Addendum No. 1

Project: Platteville Pine Street Parking Lot Reconstruction

Contract: #4-25

Project No.: D22-008

SHEET TITLE: C201

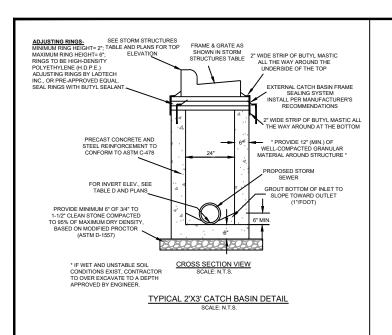
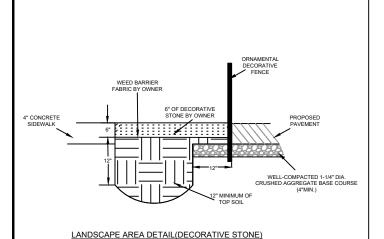
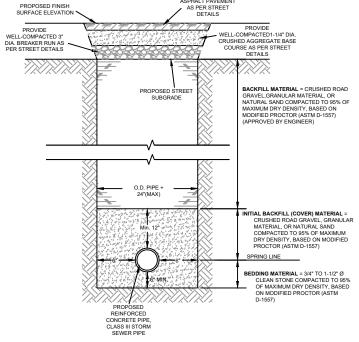
- 1. Plan Sheet C101 has been modified, see attached REVISED Plan Sheet C101.
- 2. Plan Sheet C201 has been modified, see attached REVISED Plan Sheet C201.
- 3. Plan Sheet C204 has been modified, see attached REVISED Plan Sheet C204.
- 4. Plan Sheet C205 has been modified, see attached REVISED Plan Sheet C205.

BLOCKS TO ADJUST PIPE TO GRADE	FASTEN CASTING SECURELY TO PIPE WITH WIRE 12" SDR 35 PVC PIPE	6" MINIMUM CONCRETE THICKNESS AT SIDES AND BOTTOM OF SEWER PIPE
AND ASSURE 6" MINIMUM CONCRETE THICKNESS BENEATH PIPE	SCALE: NT.S.

SLOTTED VANE DRAIN, NEENAH MODEL R-3599-A

**CONTRACTOR TO INSTALL SLOTTED VANE DRAIN AS PER MANUFACTURERS

CUT REQUIRED AT BELL TO ALLOW VANE DRAIN BASE FLANGE CLEARANCE
